**MONITORING YEAR 3
ANNUAL REPORT
FINAL**

MCLENNY ACRES MITIGATION SITE

Subject: McClenny Acres Mitigation Site – Monitoring Year 3 Report
Neuse River Basin – HUC 03020201
Wayne County
DMS Project ID No. 100038
Contract # 7423

On February 1, 2024 Wildlands Engineering received comments from the North Carolina Division of Mitigation Services (DMS) regarding the Draft Monitoring Year 3 Report for the McClenny Acres Mitigation Site. DMS comments pertaining to the stream and wetland report are reprinted below with Wildlands' responses in italics.

Figure 1 Current Condition Plan View Key

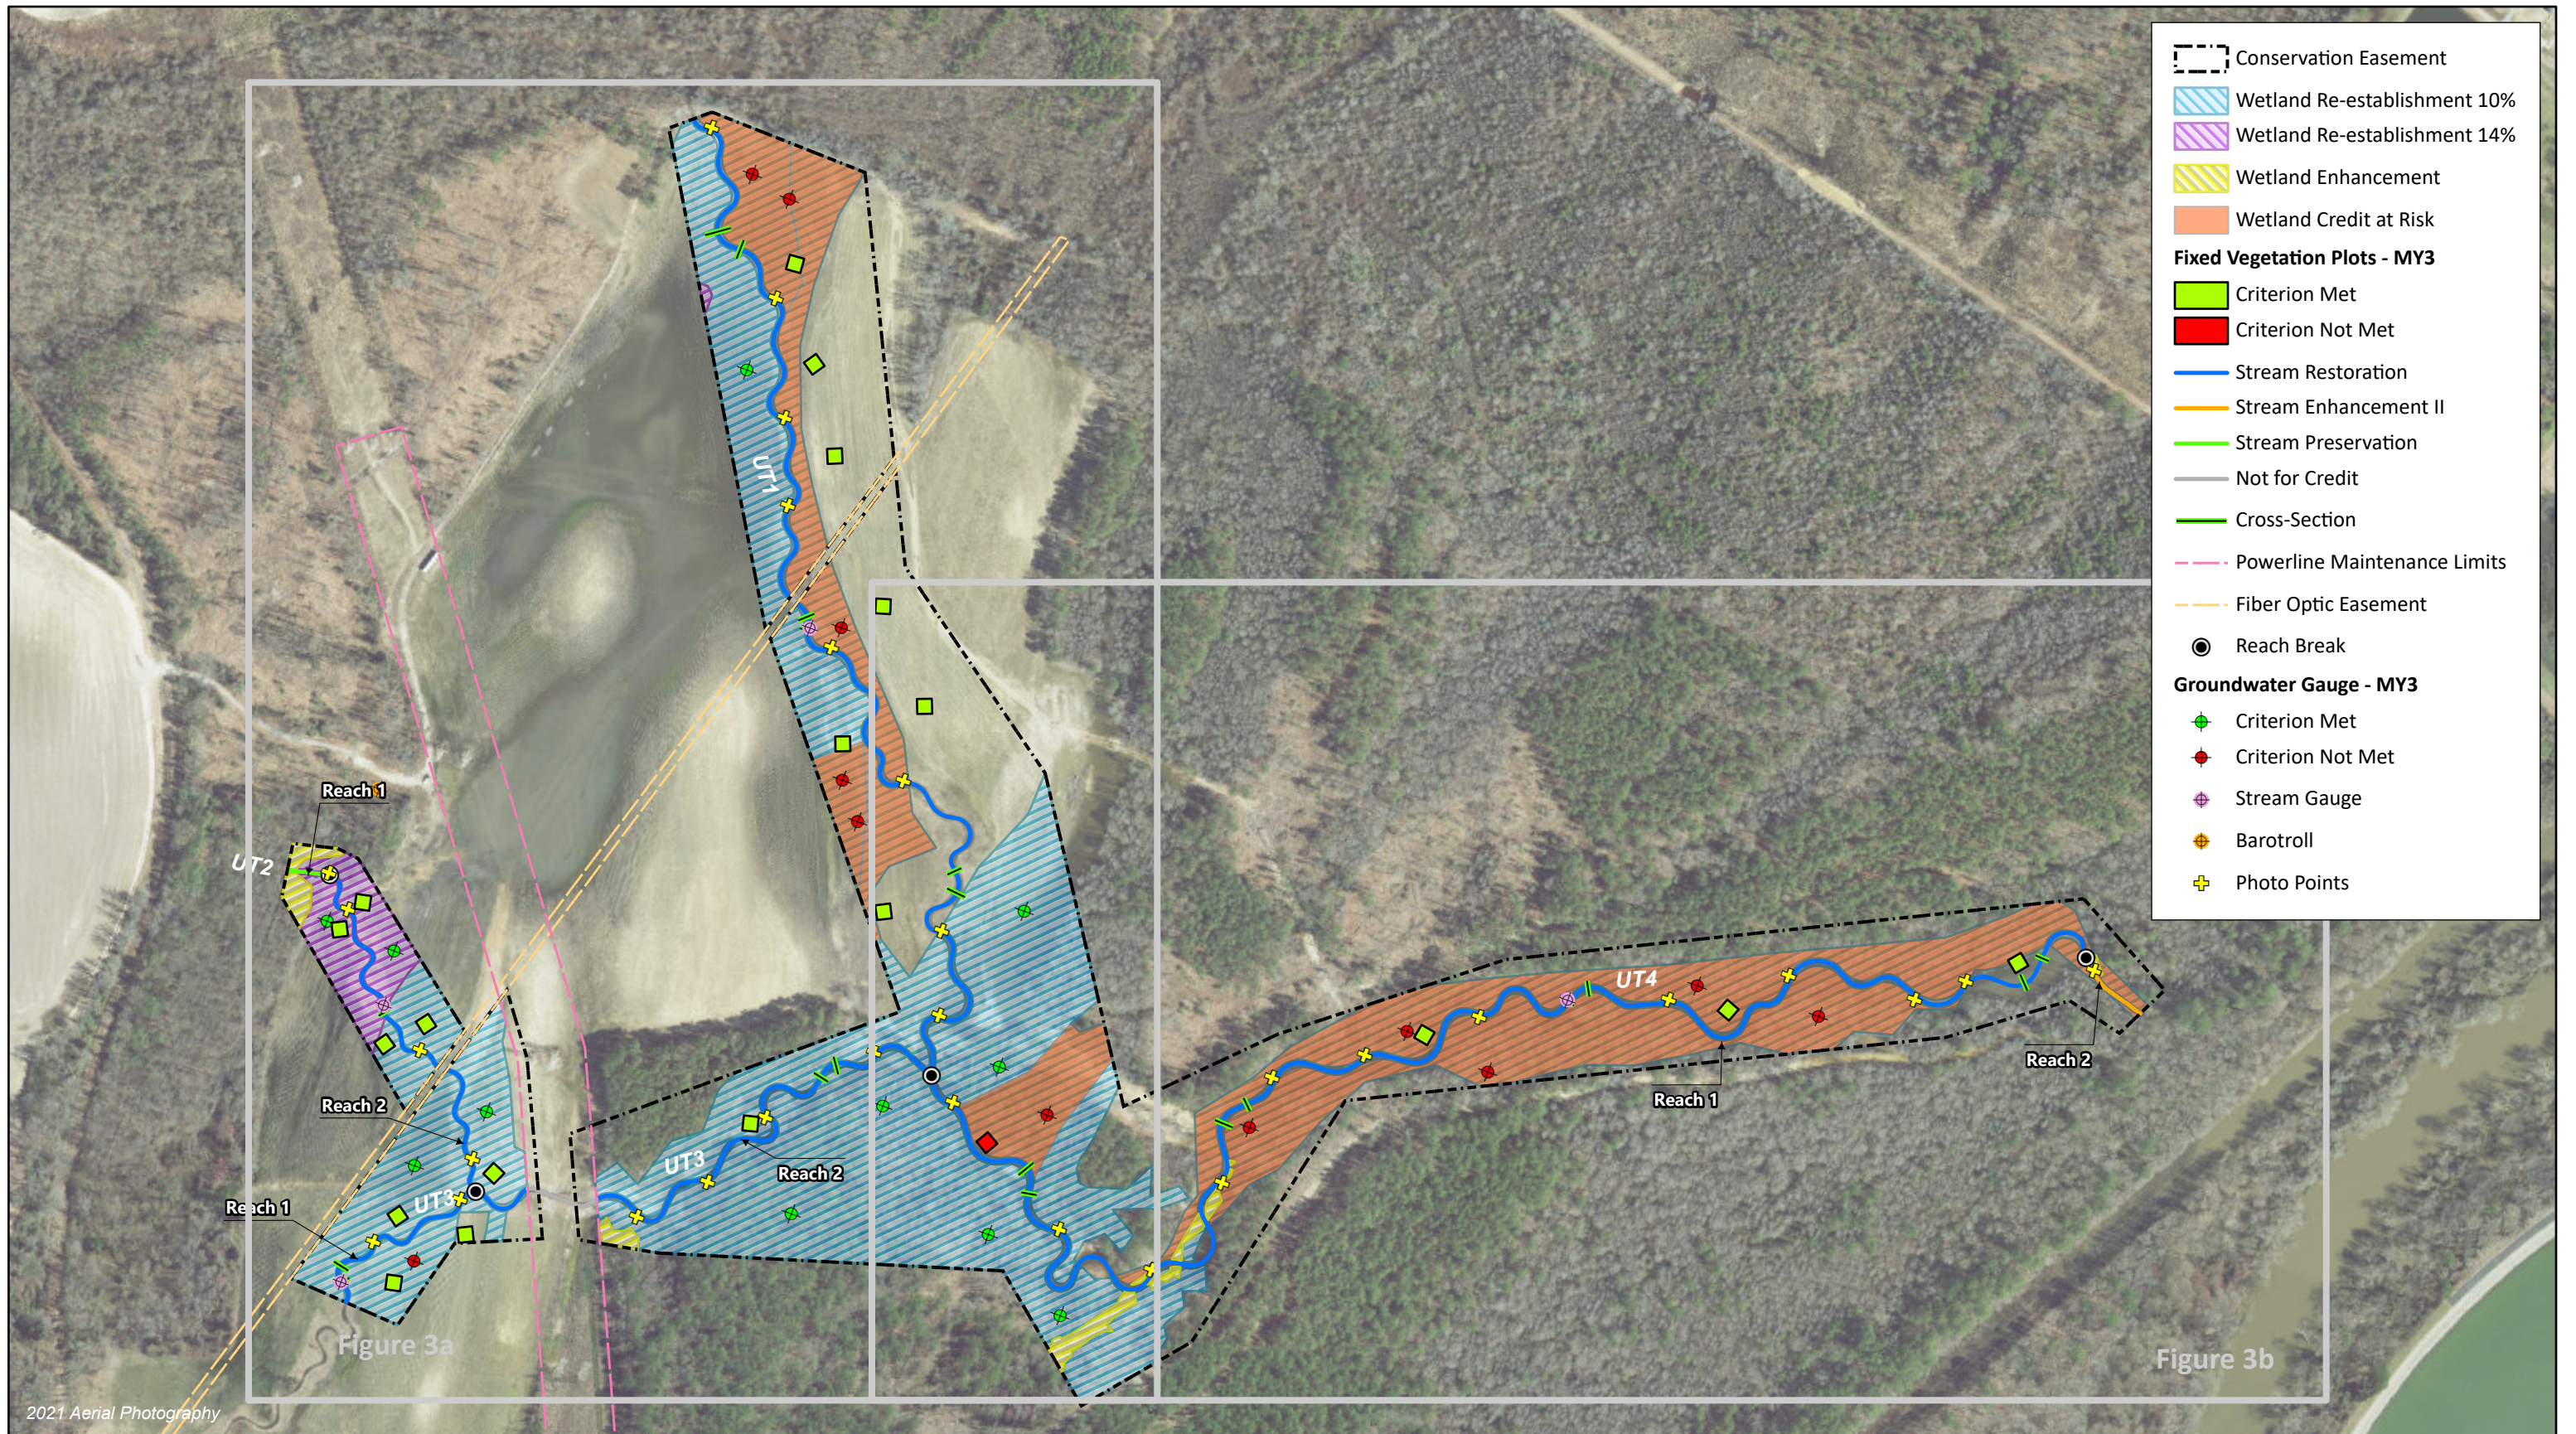
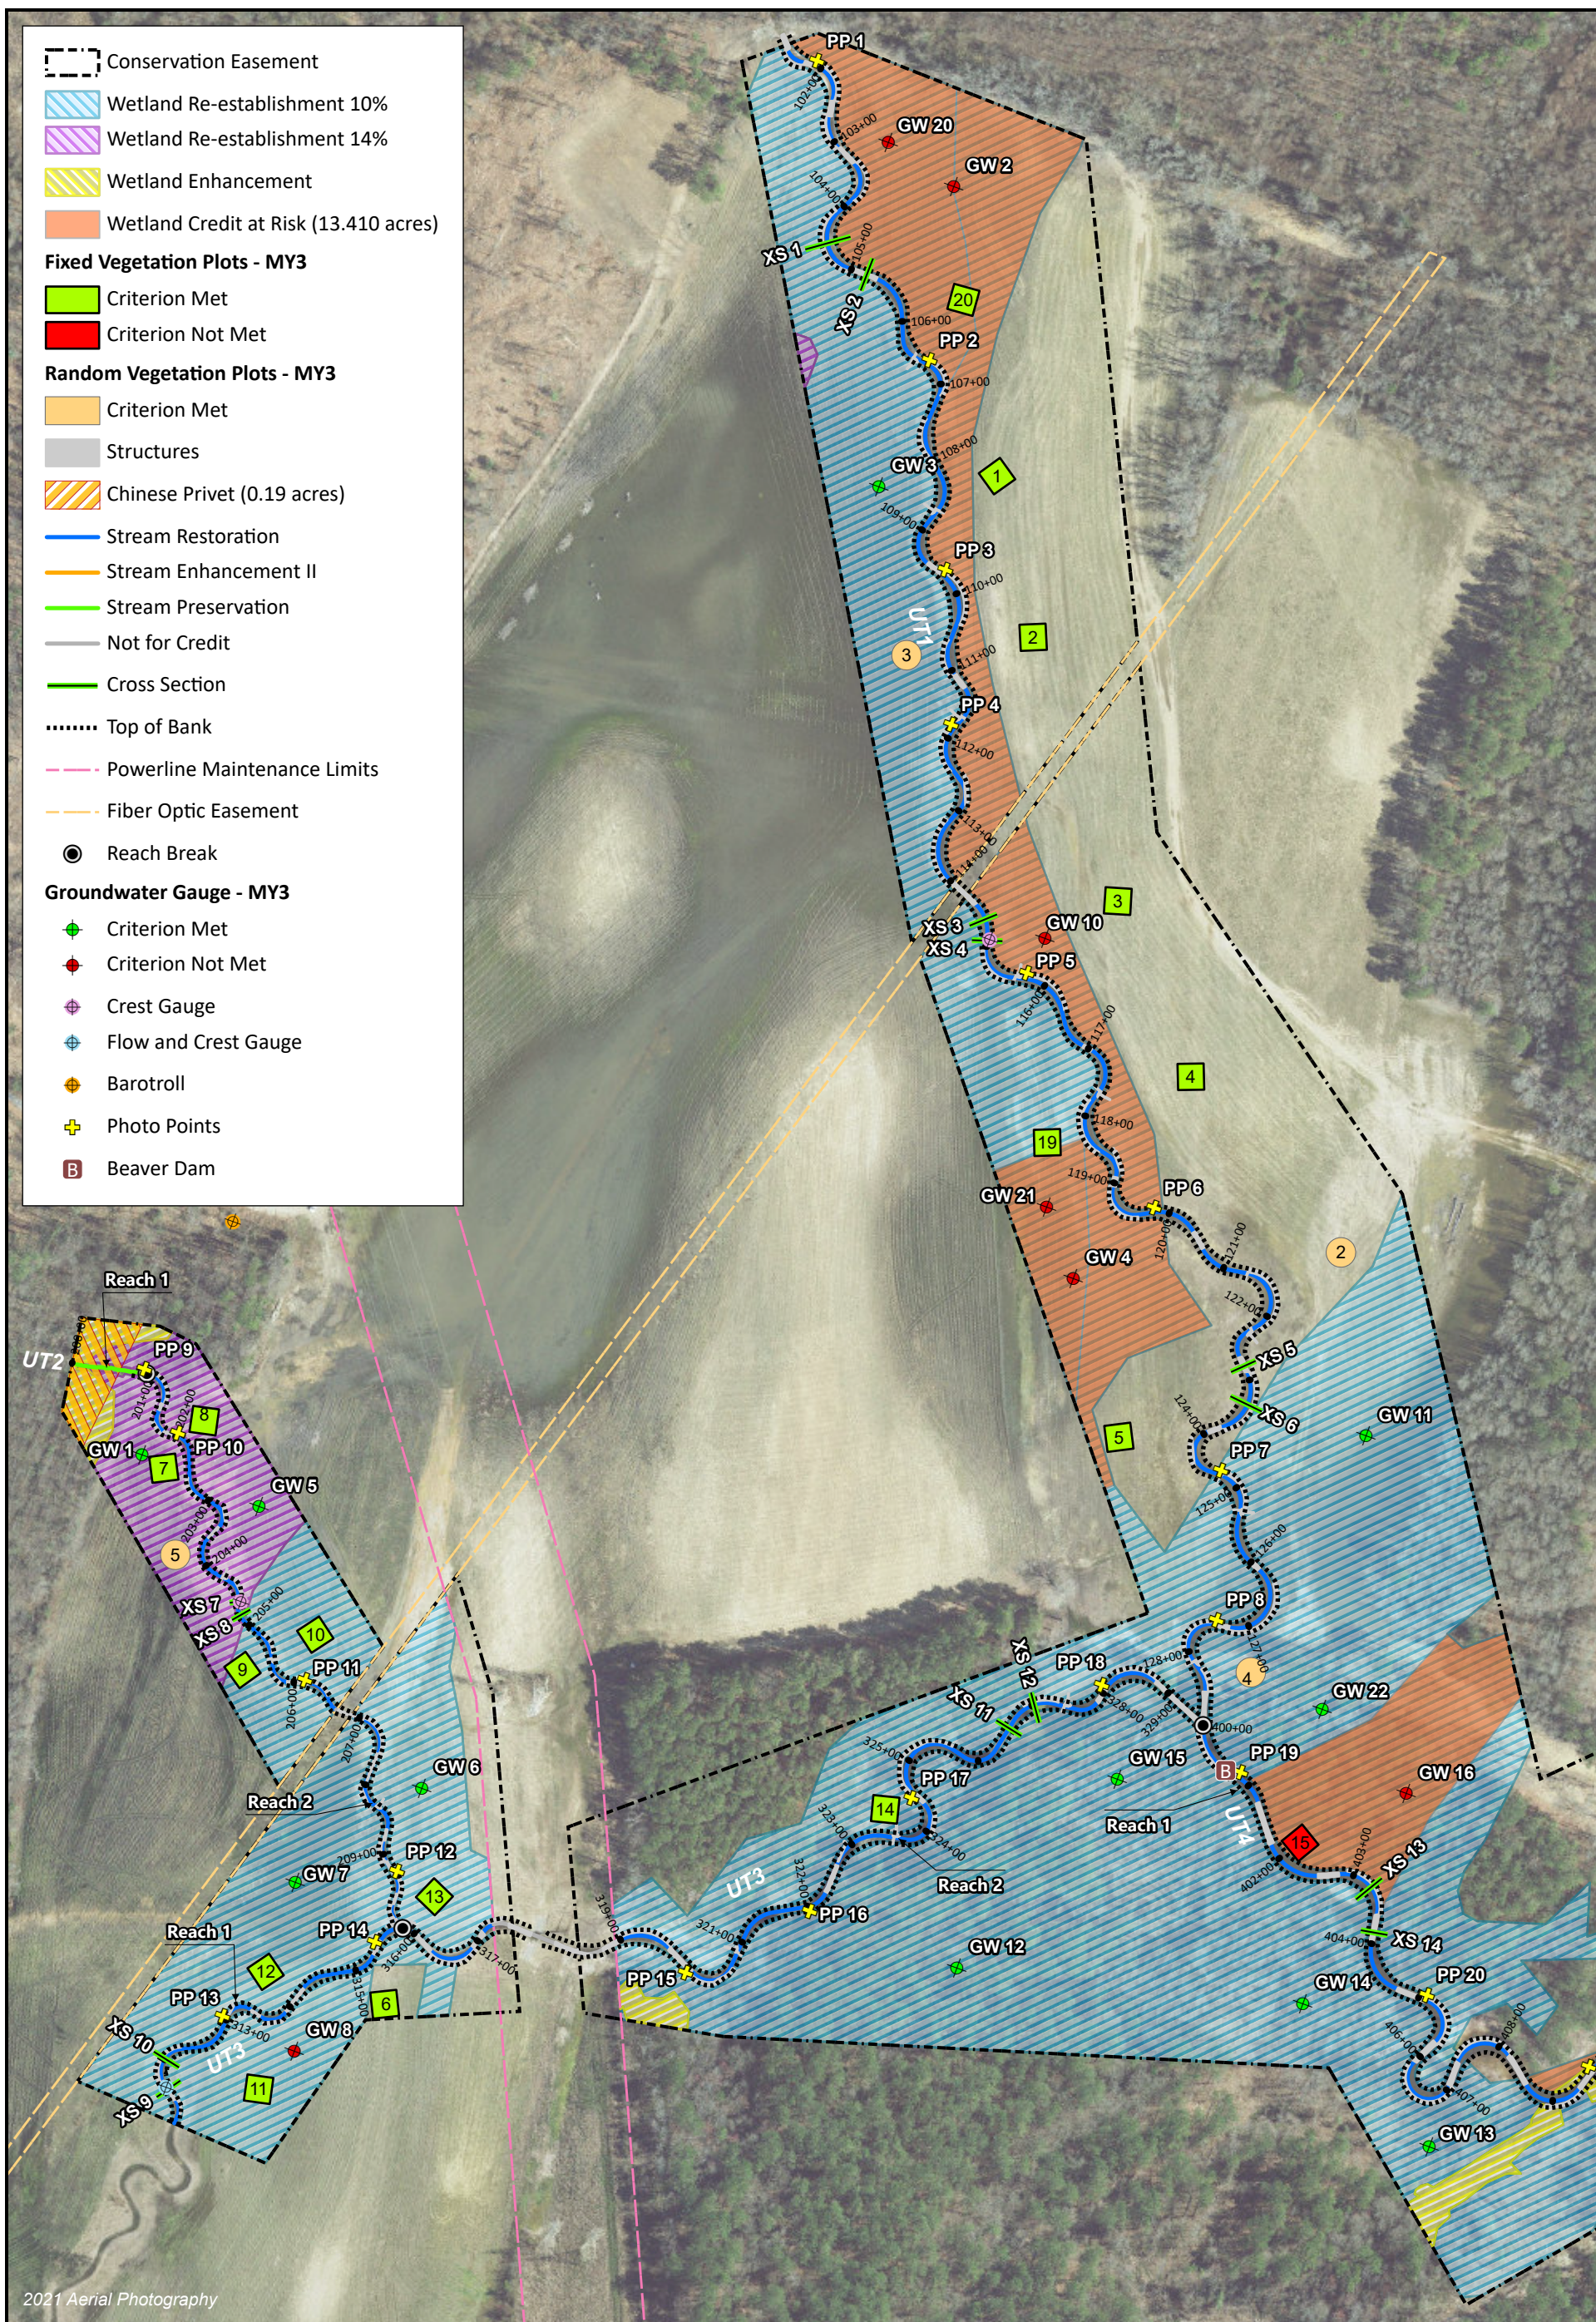
2. On Figures 1 & 1b, GW5 is mistakenly shown as not meeting success criteria.

Response: Figures were updated to correctly indicate GW 5 is meeting the success criteria.
